Enclosed please find the comments of Catskill Mountainkeeper, Delaware Riverkeeper Network, Earthjustice, the Natural Resources Defense Council and Riverkeeper on the Revised Draft Supplemental Generic Environmental Impact Statement on the Oil, Gas and Solution Mining Regulatory Program, Well Permit Issuance for Horizontal Drilling and High-Volume Hydraulic Fracturing to Develop the Marcellus Shale and Other Low-Permeability Reservoirs, issued September 7, 2011, and draft regulations (Proposed Express Terms 6 NYCRR Parts 52, 190, 550-556, 560, 750.1, and 750.3), issued September 28, 2011.

RE: Technical Comments Summary Report: Expert Team Review of the 2011 Revised Draft SGEIS on the Oil, Gas and Solution Mining Regulatory Program and Proposed High-Volume Hydraulic Fracturing Regulations

Drawing from: Presentation by Commissioner Joe Martens NYS Department of Environmental Conservation, 2011 Supplemental Generic Environmental Impact Statement for High-Volume Hydraulic Fracturing showing a 500' freshwater depth and a 4,000' HVHF well.

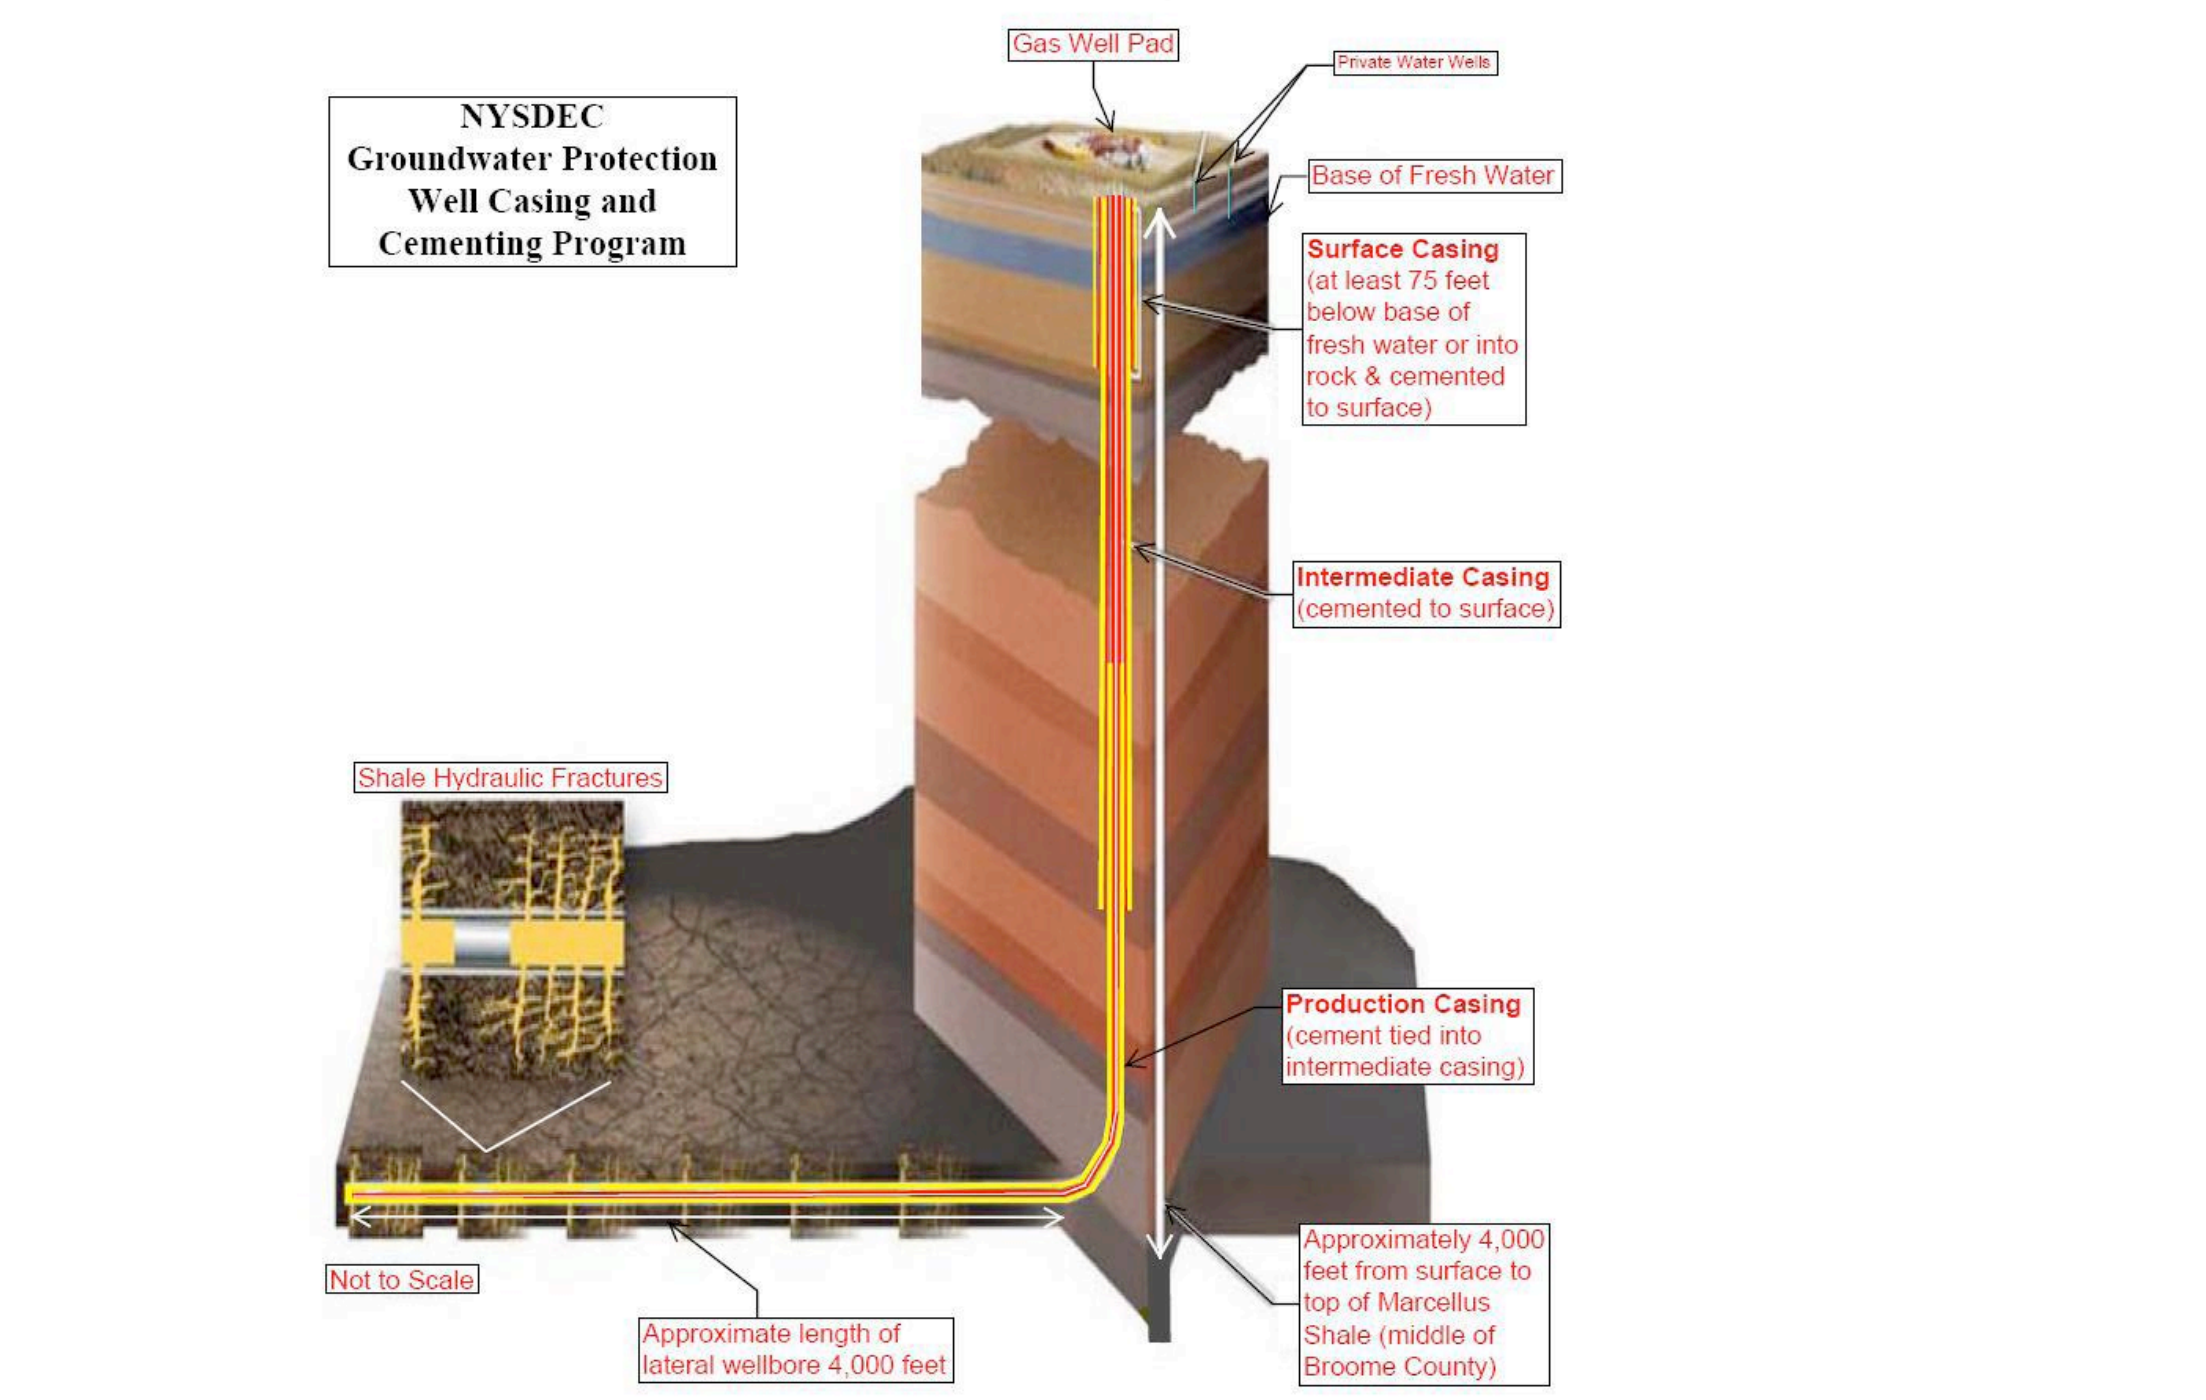
The 2011 RDSGEIS includes a wellbore schematic used in presentations given by the NYSDEC Commissioner. This wellbore schematic, shown below, depicts an example Marcellus Shale well. In the example the base of freshwater is at 500', the well is drilled to a depth of 4,000', and the horizontal length of the well is 4,000'.

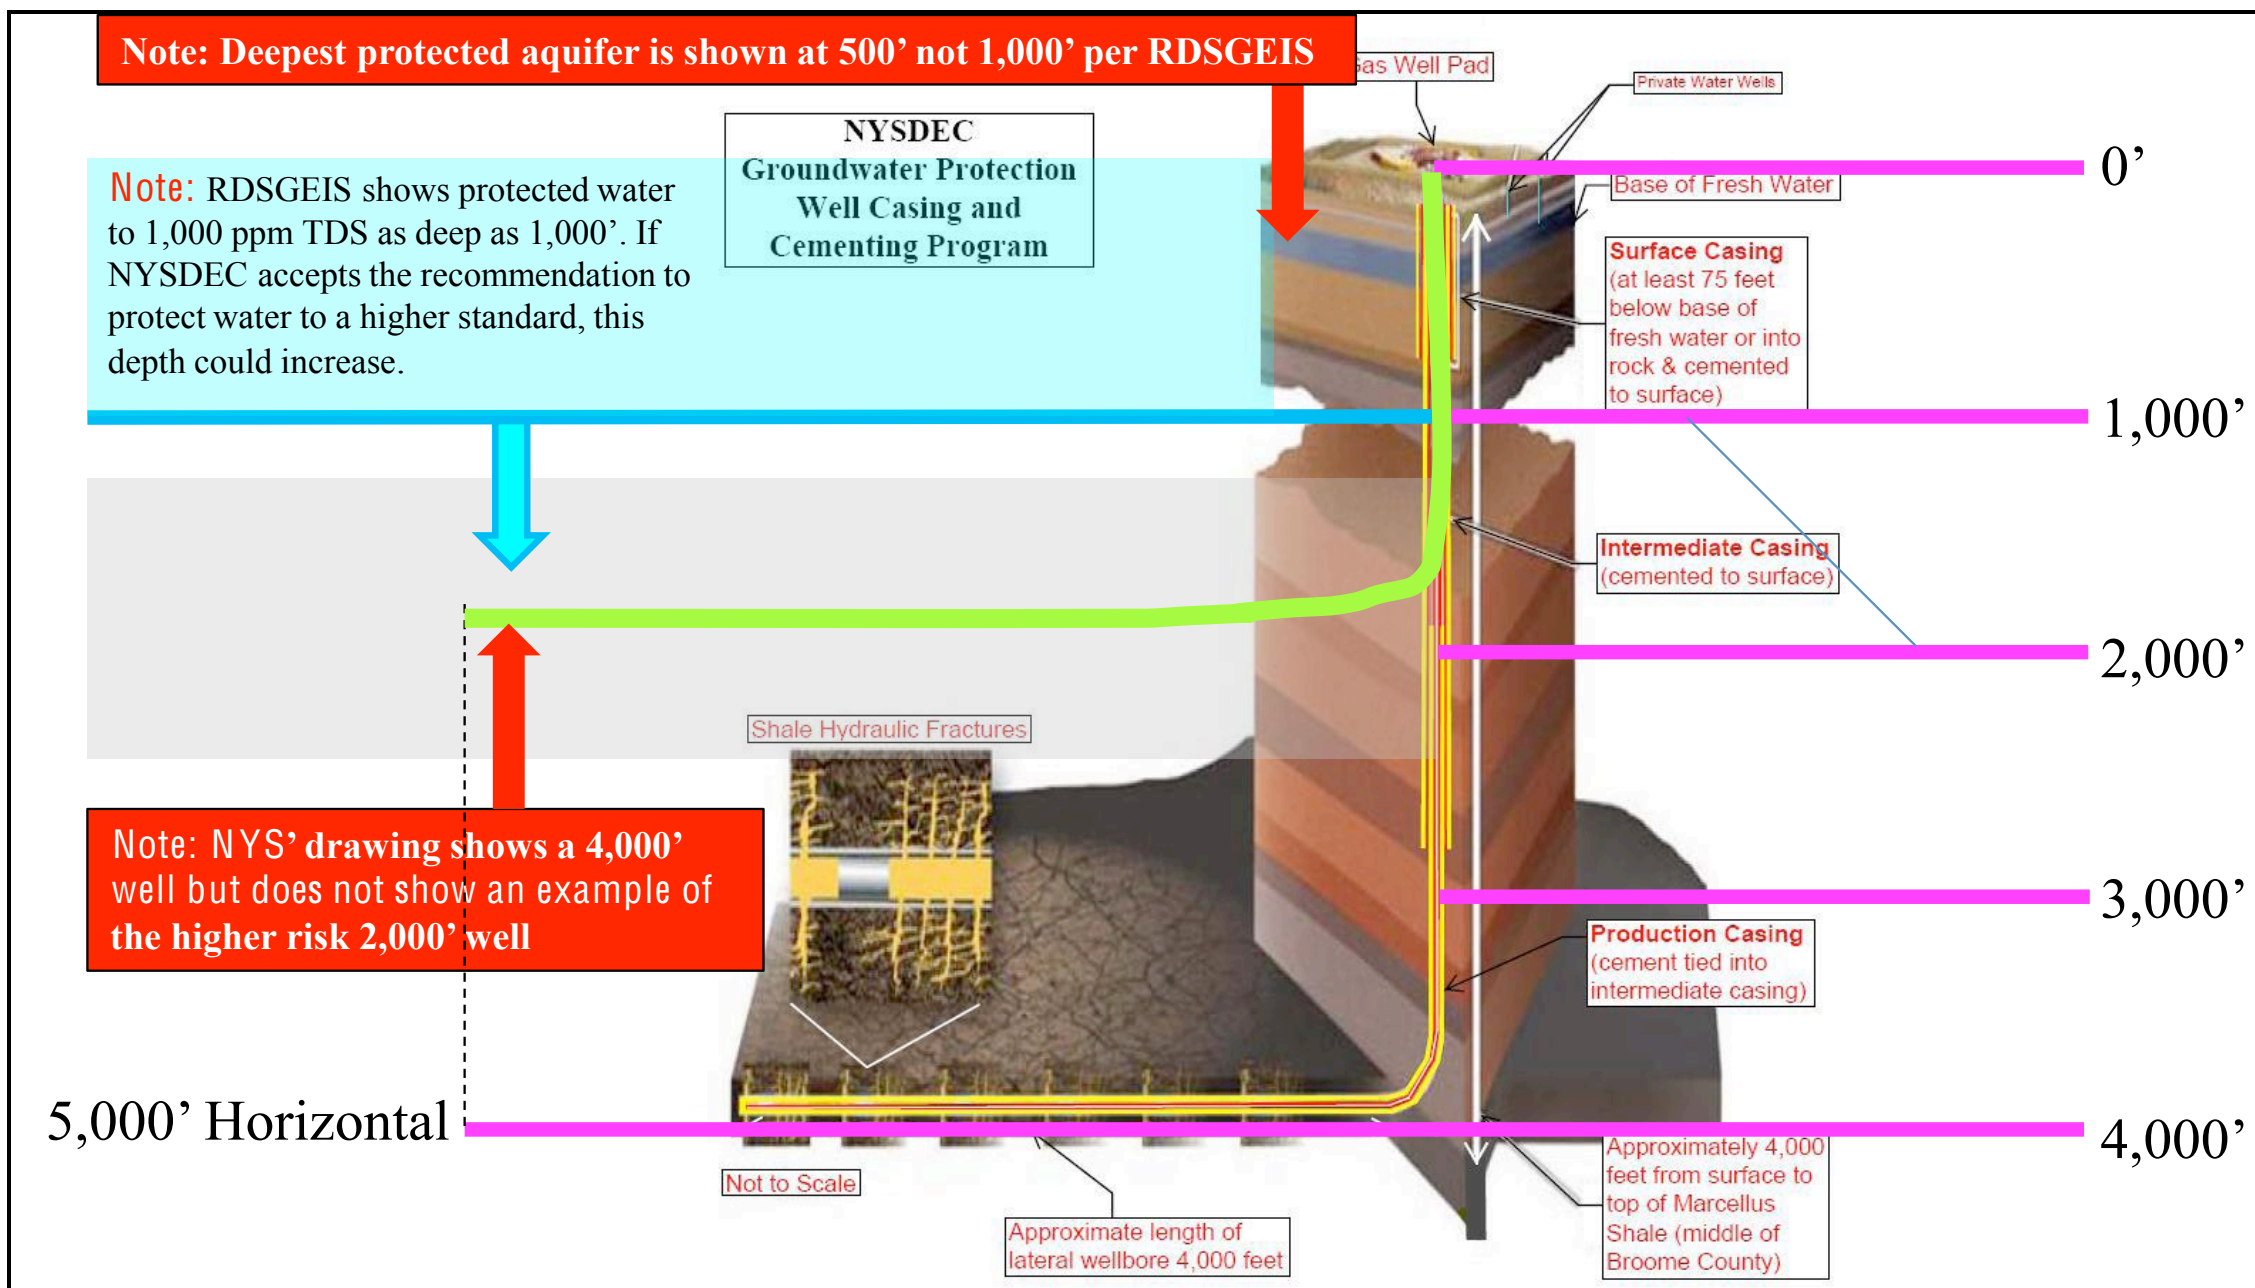
The drawing does not represent the highest risk wells proposed in the 2011 RDSGEIS. The highest risk wells allowed under the 2011 RDSGEIS would be drilled into a thin section of the Marcellus Shale at a 2,000' depth, with protected water located above at 1,000'. Below is an annotated version of this wellbore schematic, prepared by HCLLC, showing the higher risk wells proposed under the RDSGEIS.

Photo 5.7 from SGEIS
Annotated by HCLLC
Distances shown by arrows drawn to scale

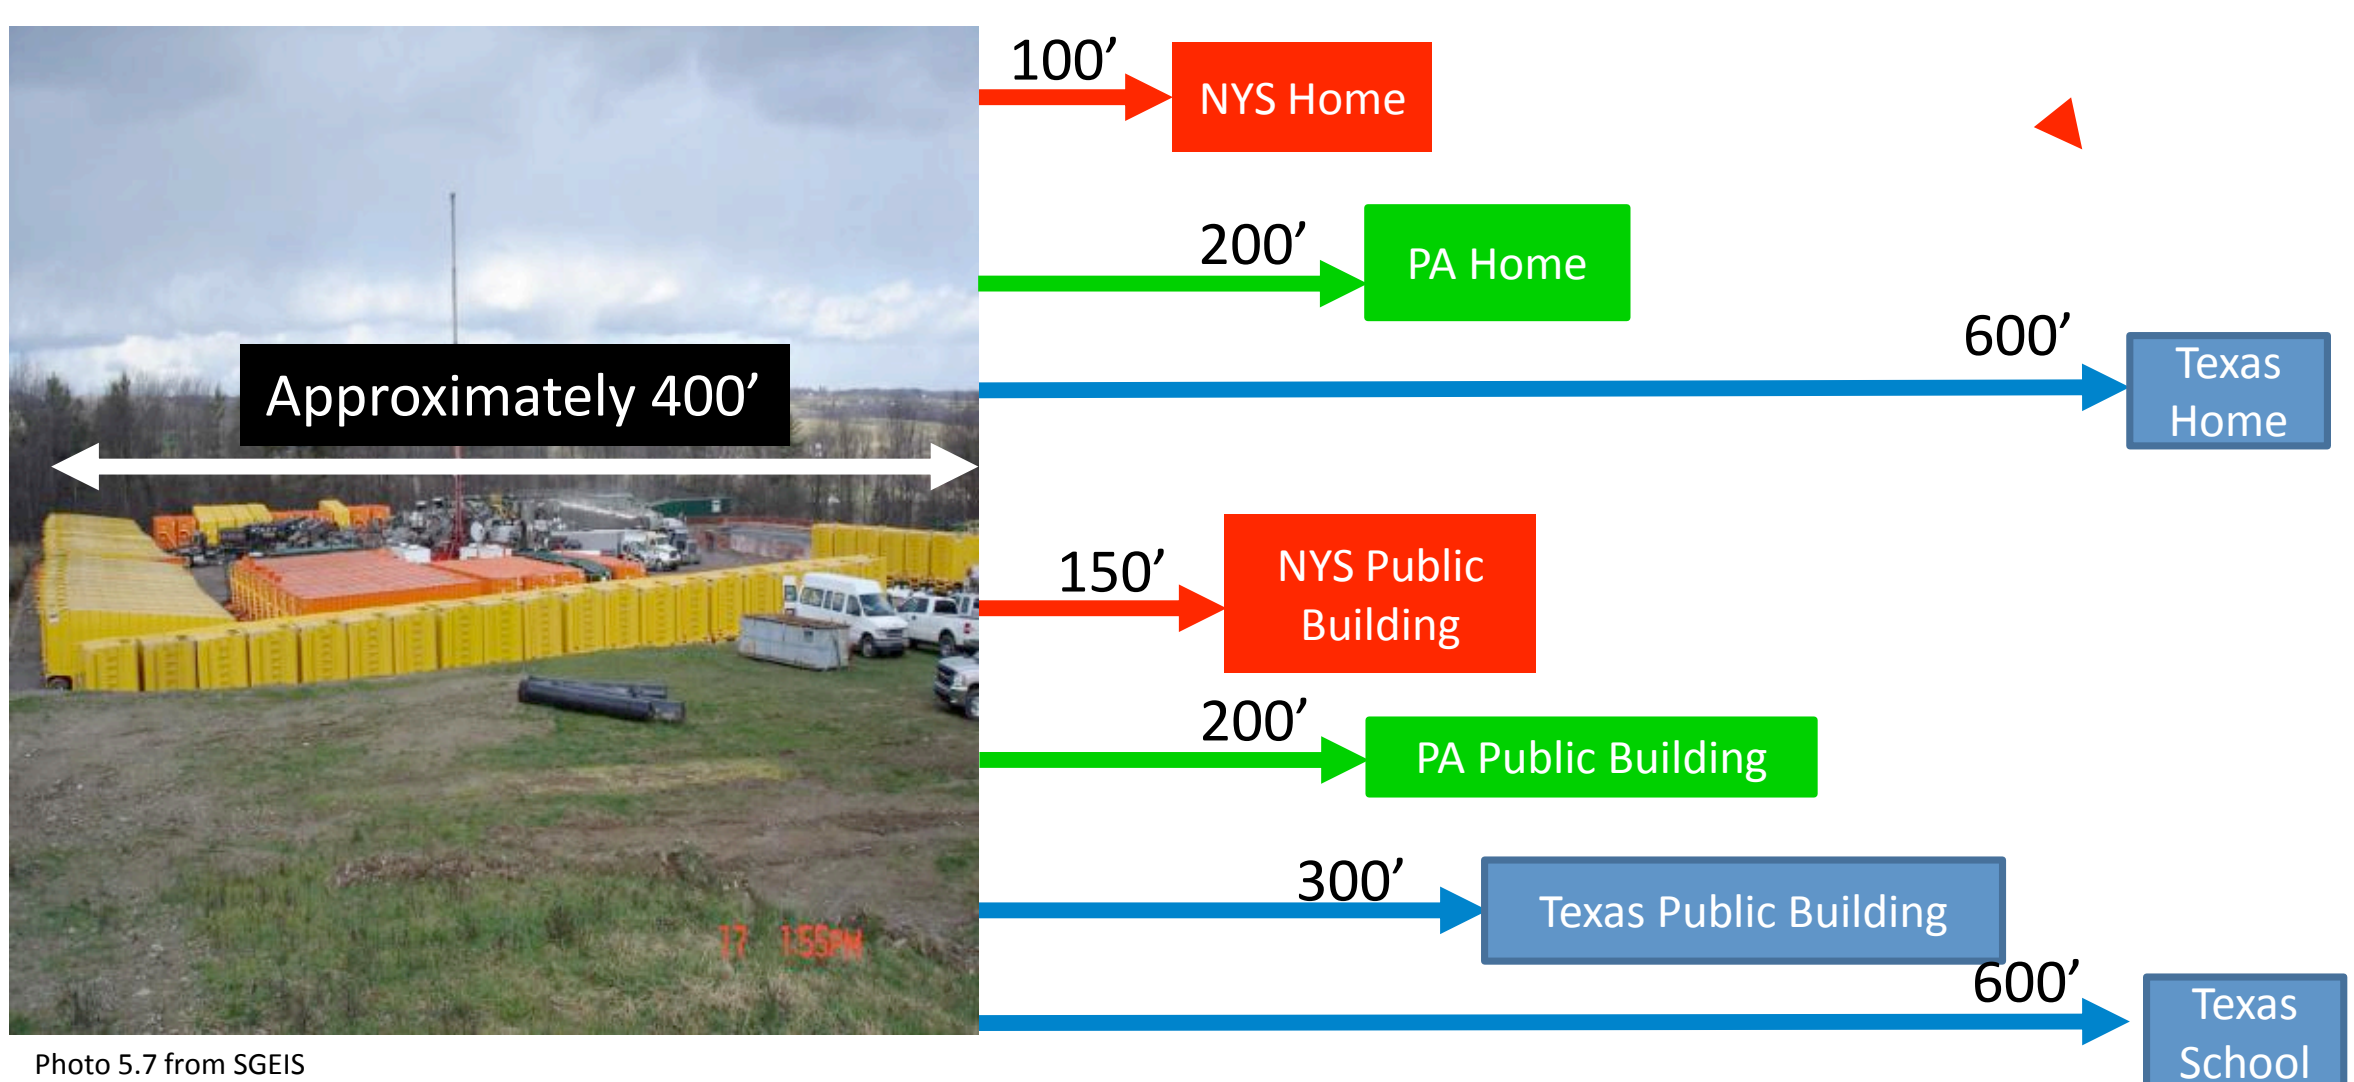
By comparison, the local zoning setback requirements for Barnett Shale development implemented in the urban area of Fort Worth, Texas are substantially larger than those proposed for NYS.[297] As shown in the figure below, the required setback from a home is six times larger at 600', as compared to NYS' 100' setback. Additionally, Fort Worth, Texas has implemented setbacks of at least 300' from public buildings and 600' from schools, which is more than double what is proposed by NYSDEC.[298]

> **Recommendation No. 68:** Improved setbacks should be included in the SGEIS as a mitigation measure and codified in the NYCRR. Specifically, the SGEIS and NYCRR should be revised at 6 NYCRR § 553.2 to include the following minimum setbacks: homes, public buildings, and schools (1,320'; ¼ mile); private and public wells, primary aquifers, and other sensitive water resources (4,000'); and other water resources (660'; 1/8 mile). Additionally, NYSDEC should clarify the authority of local zoning authorities to establish minimum setbacks that are more protective than NYS' minimum standards in order for localities to address unique and site-specific local concerns and community characteristics.
